WILLIAMSON COUNTY, TEXAS

CHANGE ORDER NUMBER: 2

Project: 22IFB110
 Roadway: SW Bypass Extension
 CSJ Number: _____

Southwest Bypass Extension Williamson County Project No. 22IFB110

SOUTHWEST BYPASS EXTENSION
ROADWAY PLAN & PROFILE

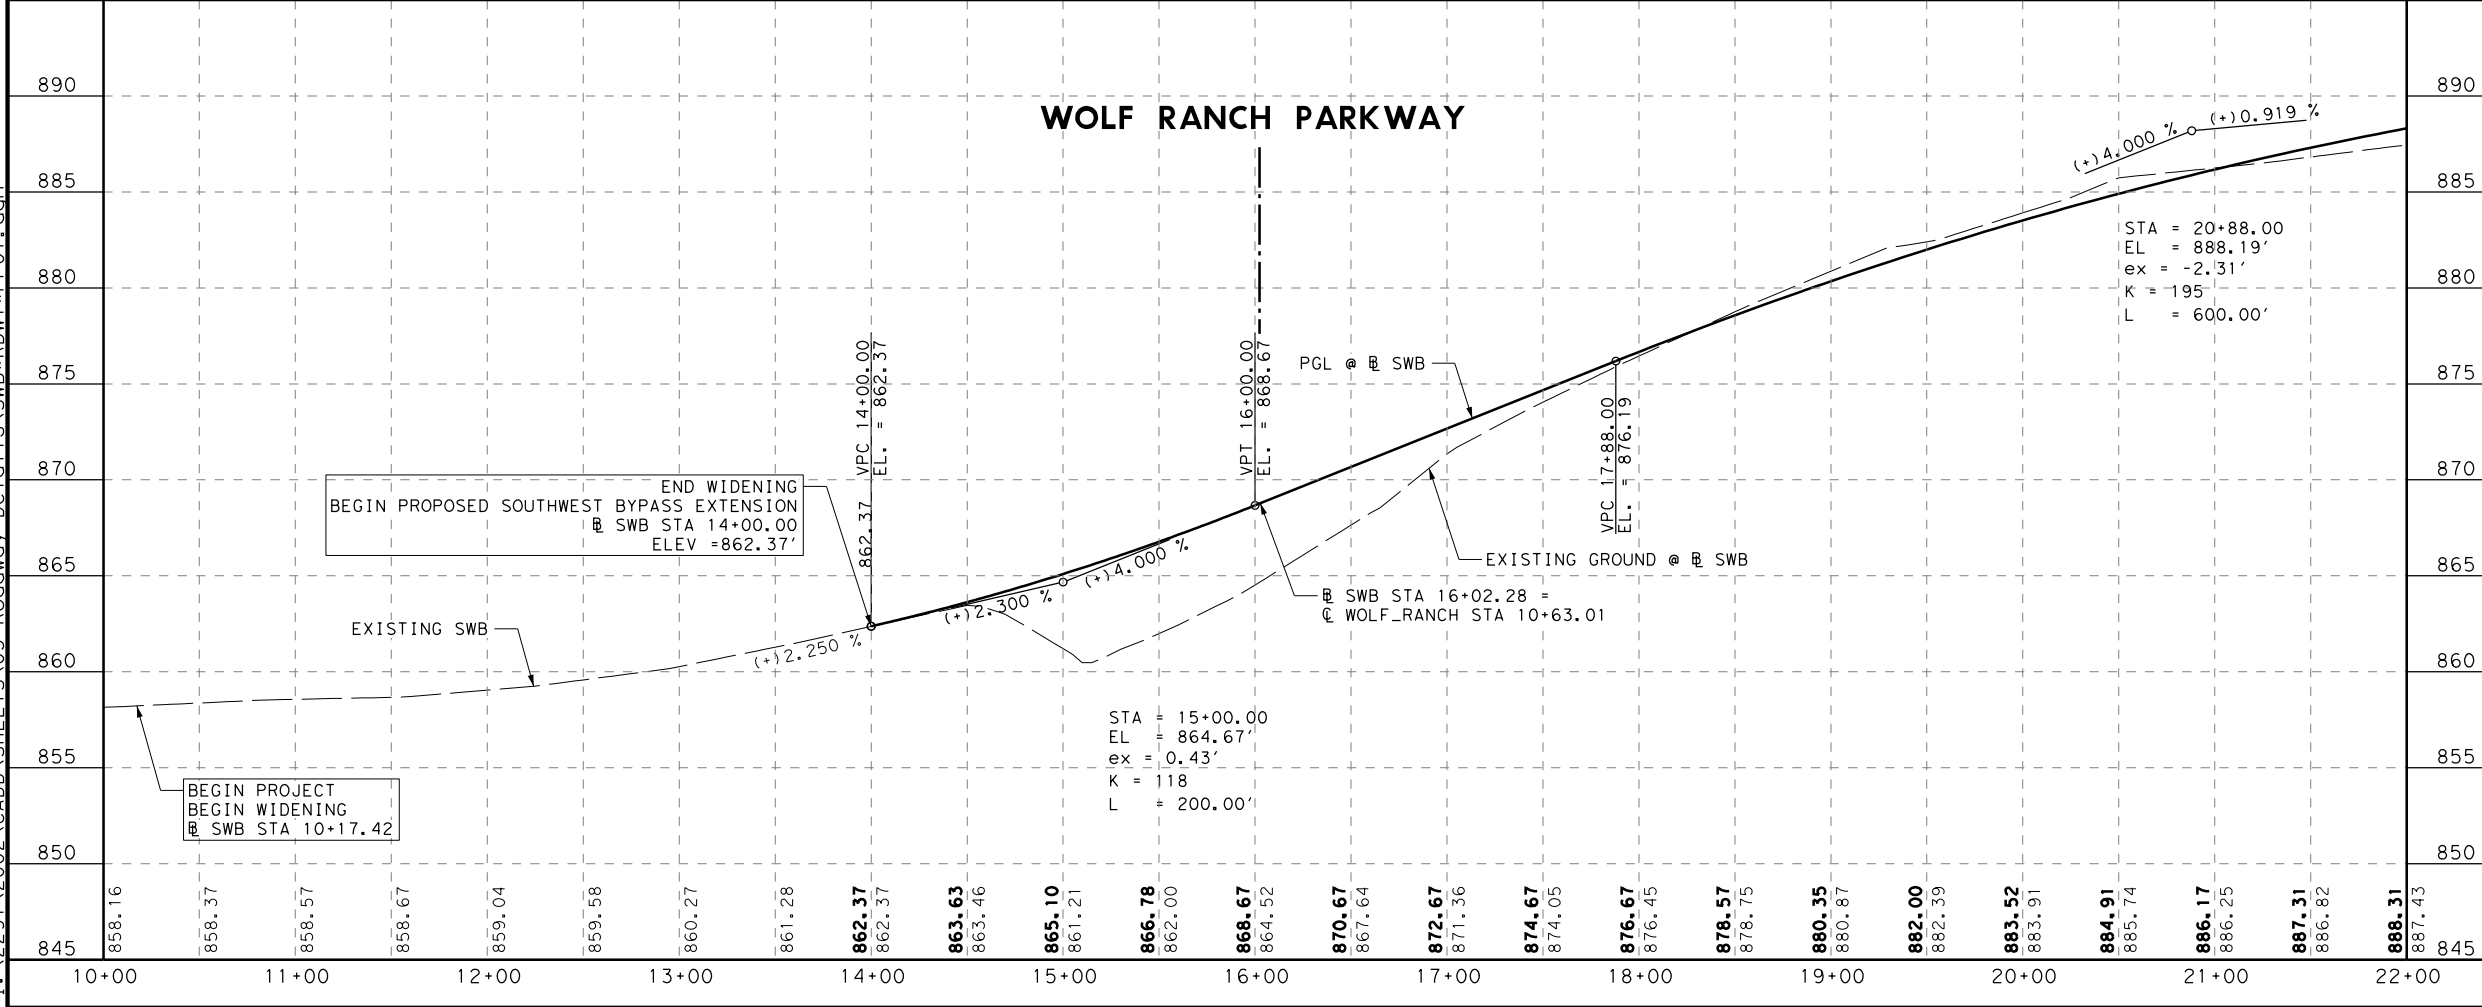
2. Differing Site Conditions (unforeseeable) 2I. Additional safety needs (unforeseeable): This Change Order compensates the contractor for adjusting the guardrail north of Wolf Ranch Parkway on Southwest Bypass due to sight distance concerns.

This Change Order compensates the Contractor for addressing a safety concern to the traveling public, regarding a guardrail in the clear zone of the roadway. The guardrail located just north of Wolf Ranch Parkway on Southwest Bypass was obstructing the view for the westbound Wolf Ranch Parkway traffic looking north on Southwest Bypass. The guardrail was shortened to address the sight distance issue.

ITEM	DESCRIPTION	QTY	UNIT
104-6054	REMOVING CONCRETE(MOW STRIP)	92	SY
160-WC01	FURN AND PLACE TOPSOIL	92	SY
500-WC01	MOBILIZATION	1	LS
502-WC01	TRAFFIC CONTROL	1	LS
542-6001	REMOVE METAL BEAM GUARD FENCE	175	LF
544-6002	GUARDRAIL END TREATMENT (MOVE & RESET)	1	EA
